Number: V2500-NAC-78-0203

SUBJECT: THRUST REVERSER ASSEMBLY - BLOCKER DOOR - REPLACE THREADED BEARINGS
WITH SWAGED BEARINGS

"MODIFICATION SERVICE BULLETIN" - "NACELLE - EXHAUST - THRUST REVERSER
ASSEMBLY - BLOCKER DOOR - REPLACE THREADED BEARINGS WITH SWAGED
BEARINGS"

Blocker Door Modification
Figure 1 (sheet 1)

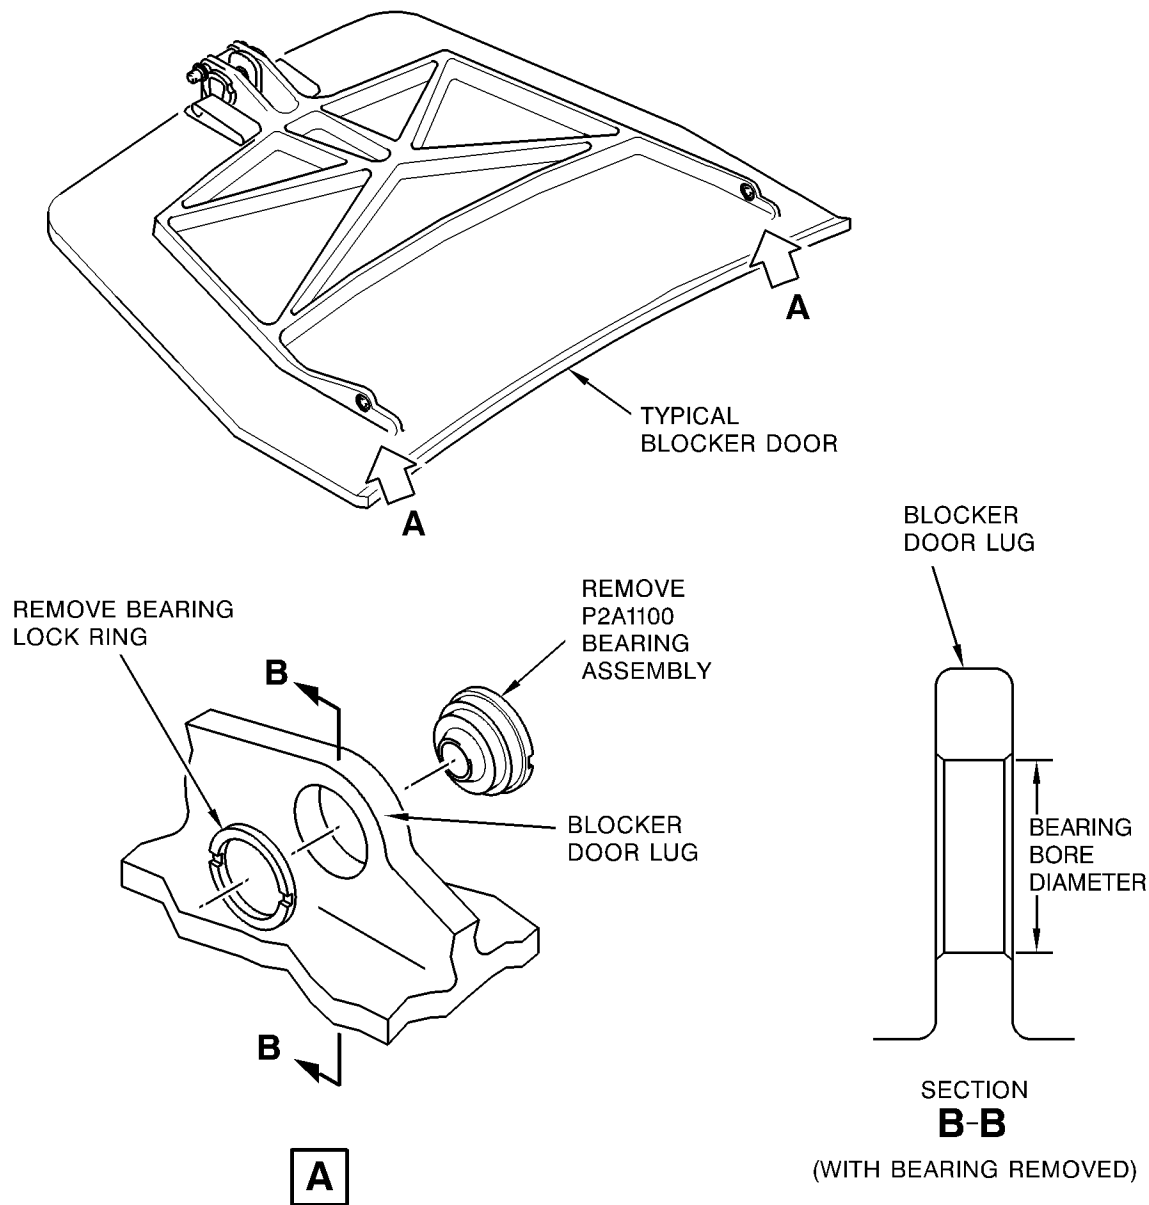
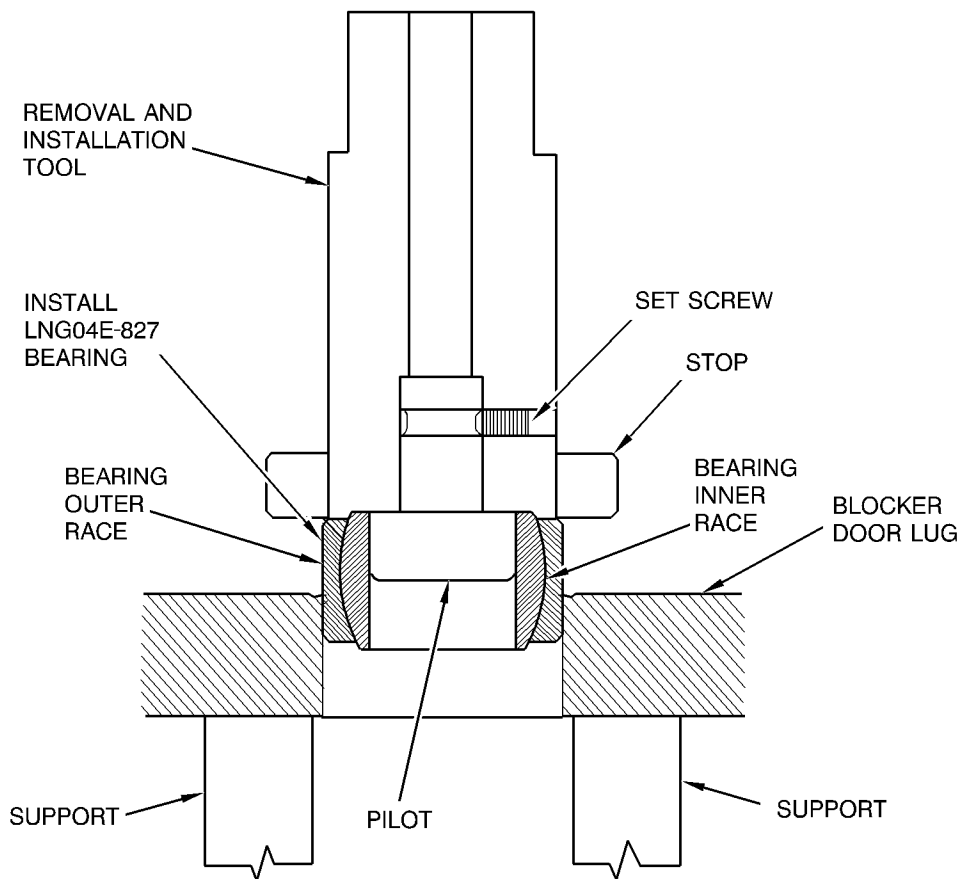
- (2) Clean the bearing holes in the blocker door with solvent (CoMat 01-438) and a lint free cloth (CoMat 02-099). Wipe the surface dry before the solvent becomes dry.
- (3) Inspect the bearing holes in the blocker door. Refer to Figure 1.
- a. Inspect the diameter of the bearing holes. Use precision measuring tools to determine the largest diameter of each hole.
1. If the diameter of the hole is 0.7084 inch (18,00 mm) or less, continue with this procedure.
 2. If the diameter of the hole is greater than 0.7084 inch (18,00 mm), refer to Component Maintenance Manual Repair VRS2449 for oversize bearing replacement.

- b. Do a liquid penetrant inspection of the lug for cracks. Refer to ASTM E 1417.
 - 1. If no cracks are found, continue with this procedure.
 - 2. If cracks are found, you must discard the blocker door.
- (4) Install the new one-piece bearings in the blocker doors. Refer to Figure 2.
 - a. Install the bearing.

- (10) Inspect the bearing holes in the blocker door. Refer to Figure 1.

a. Inspect the diameter of the bearing holes. Use precision measuring tools to determine the largest diameter of each hole.

1. If the diameter of the hole is 0.7084 inch (18,00 mm) or less, continue with this procedure.
2. If the diameter of the hole is greater than 0.7084 inch (18,00 mm), refer to Component Maintenance Manual Repair VRS2449 for oversize bearing replacement.

Blocker Door Modification
Figure 2 (sheet1)

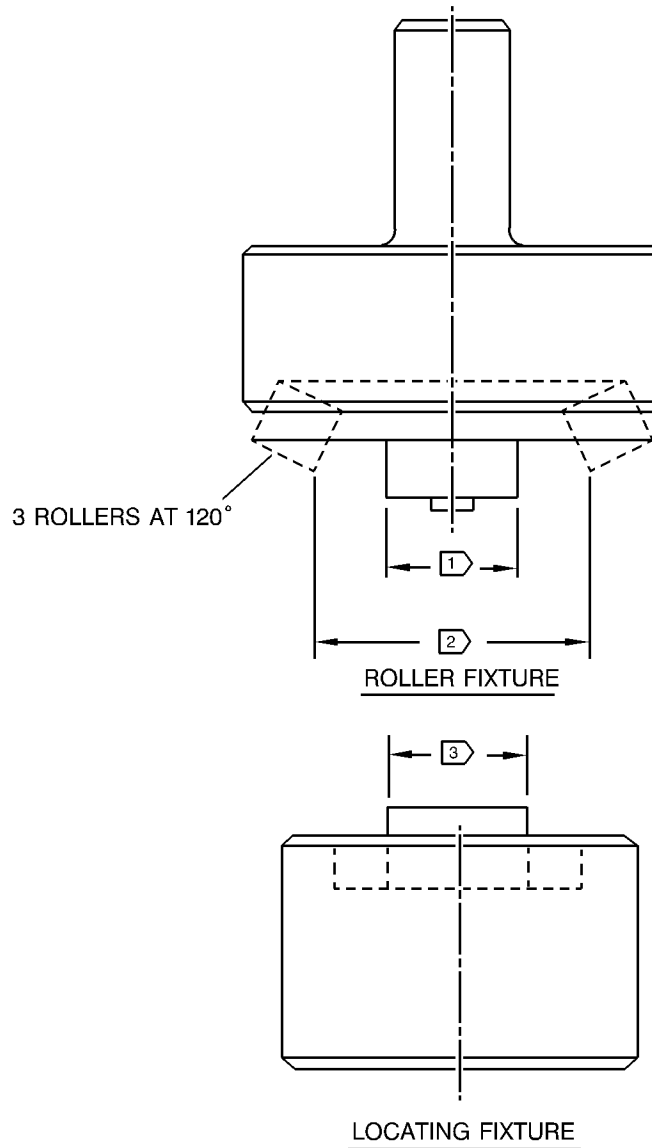
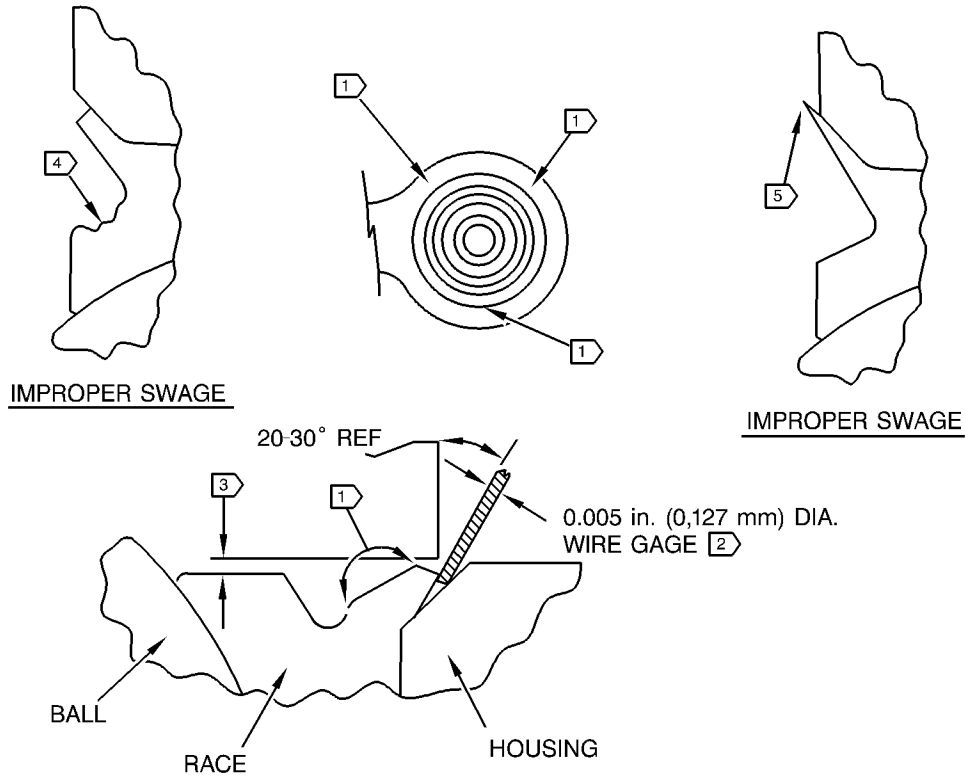
- 1. Apply primer to the inner surface of the bearing holes in the blocker door.
- 2. Press the bearing into the blocker door hole. Apply force evenly over the entire circumference of the outer race. Do not press on the inner race. Do not apply impact force to the bearing. Refer to Figure 2.
- 3. Check the bearing outer race to make sure it is even with the surface of the lug or no more than 0.010 inch (0,25 mm) above or below the surface of the lug. Refer to Figure 2.
- 4. Swage the bearing into the lug. Use roller swaging tool RST4183. Refer to Figure 2.
 - (a) If you use a power tool to operate the swaging tool, set the speed of the power tool to a speed of approximately 100 RPM or less. Do not exceed 100 RPM.
 - (b) Use the minimum force required to swage the grooved lip of the bearing over the lug.

- (c) The swage is complete when the swaged lip of the bearing is in contact with the lug chamfer.

5. Examine the bearing installation. Refer to Figure 2.

- (a) Visually examine the blocker door lug for cracks. Do a liquid penetrant inspection if cracks are suspected (Refer to ASTM E 1417). Reject any door with cracked lugs.

- (b) Make sure the ball of the bearing turns freely after swaging. Reject any bearings that do not have a ball that turns freely. If you reject the bearing, repeat the installation procedure with a new bearing.

- (c) Visually examine the swaged portion of the bearing for galling or cracks. Any crack or galling is cause for rejection of the installation. If you reject the installation, repeat the installation procedure with a new bearing.

- (d) Measure the gap between the swaged portion of the bearing and the lug. A 0.005 inch (0,127 mm) gap is permitted in 40% or less of the swaged circumference. Too much gap is cause for rejection of the installation. If you reject the installation, repeat the installation procedure with a new bearing.

(11) Install the new one-piece bearings in the blocker door. Refer to Figure 2.

1. Apply primer to the inner surface of the bearing holes in the blocker door.
2. Press the bearing into the blocker door hole. Apply force evenly over the entire circumference of the outer race. Do not press on the inner race. Do not apply impact force to the bearing. Refer to Figure 2.
3. Check the bearing outer race to make sure it is even with the surface of the lug or no more than 0.010 inch (0,25 mm) above or below the surface of the lug.
4. Swage the bearing into the lug. Use roller swaging tool RST4183. Refer to Figure 2.
 - (a) If you use a power tool to operate the swaging tool, set the speed of the power tool to a speed of approximately 100 RPM or less. Do not exceed 100 RPM.
 - (b) Use the minimum force required to swage the grooved lip of the bearing over the lug.
 - (c) The swage is complete when the swaged lip of the bearing is in contact with the lug chamfer.

5. Examine the bearing installation. Refer to Figure 2.
- (a) Visually examine the blocker door lug for cracks. Do a liquid penetrant inspection if cracks are suspected (refer to ASTM E 1417). Reject any door with cracked lugs.

- (b) Make sure the ball of the bearing turns freely after swaging. Reject any bearings that do not have a ball that turns freely. If you reject the bearing, repeat the installation procedure with a new bearing.

- (c) Visually examine the swaged portion of the bearing for galling or cracks. Any crack or galling is cause for rejection of the installation. If you reject the installation, repeat the installation procedure with a new bearing.

- (d) Measure the gap between the swaged portion of the bearing and the lug. A 0.005 inch (0,127 mm) gap is permitted in 40% or less of the swaged circumference. Too much gap is cause for rejection of the installation. If you reject the installation, repeat the installation procedure with a new bearing.

- 1 PILOT DIAMETERS: 0.0015 in. (0,038 mm) MINIMUM CLEARANCE WITH BEARING BORE.
- 2 PITCH DIAMETER: MAXIMUM SWAGING GROOVE PITCH DIAMETER
+0.010 in. (0,25 mm), -0.005 in. (0,127 mm)
- 3 OTHER DIMENSIONS TO SUIT BEARING SIZE.

- 1 VISUALLY INSPECT THIS CIRCUMFERENTIAL AREA FOR CRACKS AND SEPARATIONS.
- 2 INSPECT CIRCUMFERENCE OF THE GAP IN THE SWAGED LIP AS SHOWN WITH 0.005 in. (0,127 mm) FEELER GAGE. A PROPERLY SWAGED BEARING IN AN OPTIMALLY PREPARED HOUSING WILL NOT ACCEPT THE FEELER GAGE, HOWEVER, NO MORE THAN 40% OF THE CIRCUMFERENCE MAY ACCEPT THE GAGE.
- 3 BEARING RACE FACE TO BE FLUSH WITH HOUSING +0.000/-0.010 in. (+0,00/-0,25mm)
- 4 VISUALLY INSPECT INNER FACE OF BEARING GROOVE TO ASSURE THERE IS NO EVIDENCE OF ROLLER CONTACT DURING THE SWAGING OPERATION.
- 5 VISUALLY INSPECT THE SWAGED PORTION OF THE SWAGED LIP TO ASSURE THAT OVER-SWAGING HAS NOT OCCURRED.

Blocker Door Modification
Figure 3 (sheet 2)

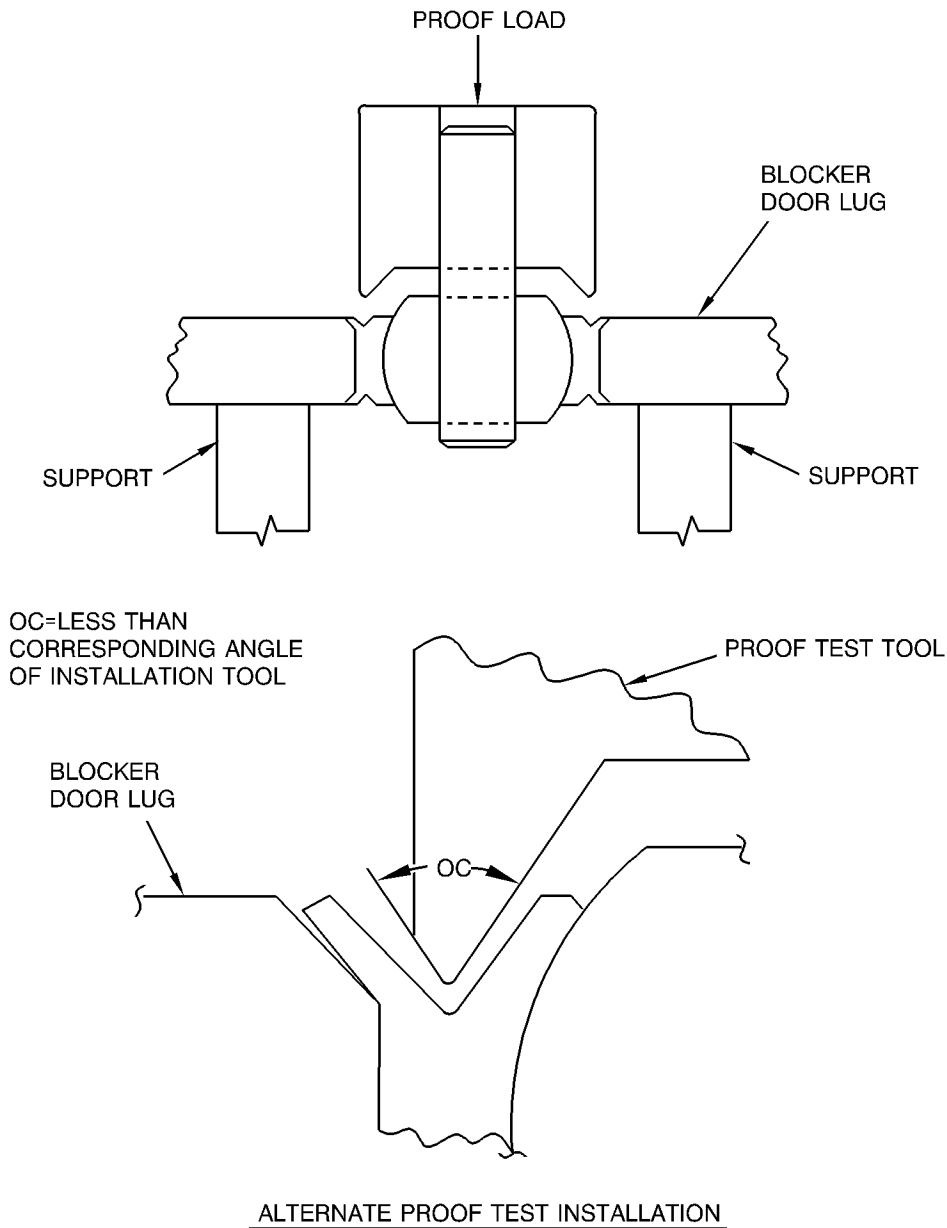
- (5) Do an axial load proof test on the new bearings. Refer to Figure 3.
- a. Apply a 1150 lbs (521 kg) axial load to the outer race on one side of the bearing and then on the other side.

1. Any deflection between the bearing outer race and the blocker door lug is cause for rejection of the installation. If you reject the installation, repeat the installation procedure with a new bearing.
- (6) Re-identify the blocker door assemblies and blocker doors. Use a rubber stamp and ink. Refer to the Standard Practices/Processes Manual (SPP-V2500-1IA), Chapter 70-09-00.

- (12) Do a axial load proof test on the new bearings. Refer to Figure 3.
- a. Apply a 1150 lbs (521 kg) axial load to the outer race on one side of the bearing and then on the other side.

- 1. Any deflection between the bearing outer race and the blocker door lug is cause for rejection of the installation. If you reject the installation, repeat the installation procedure with a new bearing.
